## PLAN REVIEW SHEET

<b>Date:</b>	10/31/2007	<b>Staff Contact:</b>	David McDonald
<b>Petitioner:</b>	Galleria Partners I, LLC	<b>Telephone:</b>	704-336-6900
<b>Petition:</b>	2008-006	<b>Fax:</b>	704-432-1277
		<b>Email:</b>	<a href="mailto:dmcDonald@ci.charlotte.nc.us">dmcDonald@ci.charlotte.nc.us</a>
<b>Location:</b>	+/- 1.96 acres, Northwest of Galleria Blvd & Galleria Club Ln.	<b>Attachments:</b>	Shelter_Concrete_Standards.pdf (See 60.03A); Site Plan Transit Exhibit.pdf
<b>Existing Zoning:</b>	CC Vacant		
<b>Requested Zoning:</b>	UR-2(CD) (To build 48 3-story apartments as a Phase II of adjacent Galleria Village Apartments)

#### *FIRST SUBMITTAL*

CATS acknowledges receipt of the rezoning application and site plan and submits the following to the petitioner:

STD. NO.	REV.
60.03A

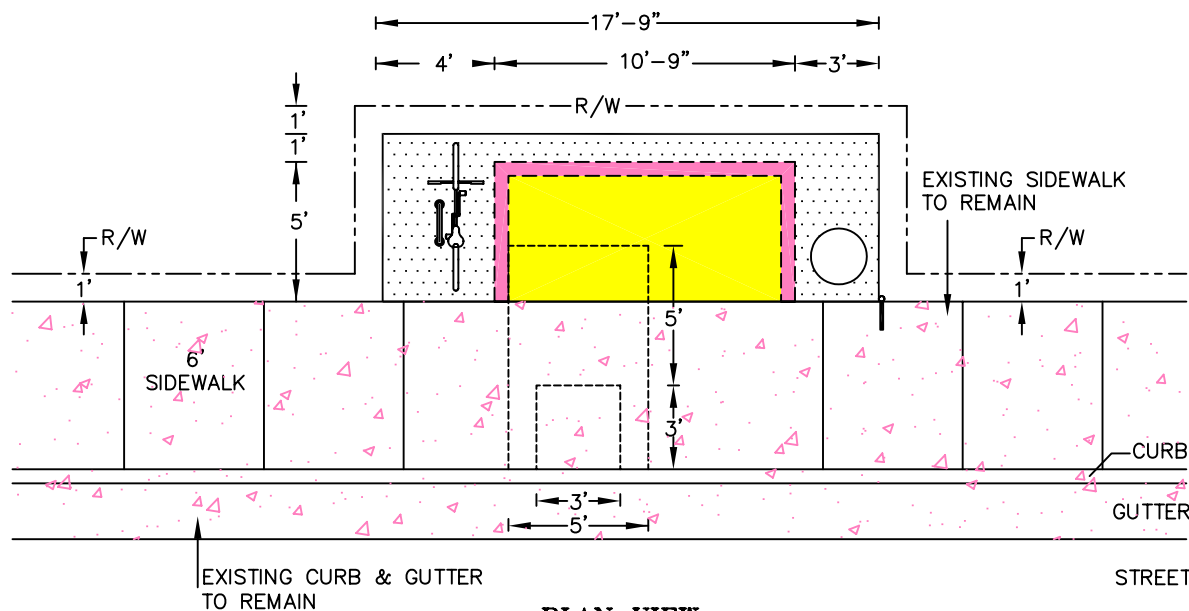
- 1) CATS Route 27 Monroe Road currently serves Monroe Road and Sardis Road North. CATS has received customer requests to service the internal development of Galleria Shopping Center.
- 2) In order to permit a safe location for bus operations within the development, CATS requests a bus pullout to be constructed with heavy-duty pavement to enable bus-travel and a bus layover. The bus pullout should be located approximately 40' South of the cross walk median and designed to provide for a minimum 60' full bay length, 10' full bay width, a 4:1 entry taper, 3:1 exit taper, and a 30' R at all transition points (see attached exhibit).
- 3) CATS additionally requests a shelter pad on Galleria Blvd. near the location of the bus pullout, constructed to CATS Development Standards 60.03 A (see attached standards).

Please designate such in the site plan and/or accompanying notes. Please contact Leonard Ganther (CATS Operations) @ 704.432.1283 prior to demolition or construction, to coordinate the final location of the bus pullout and shelter pad.
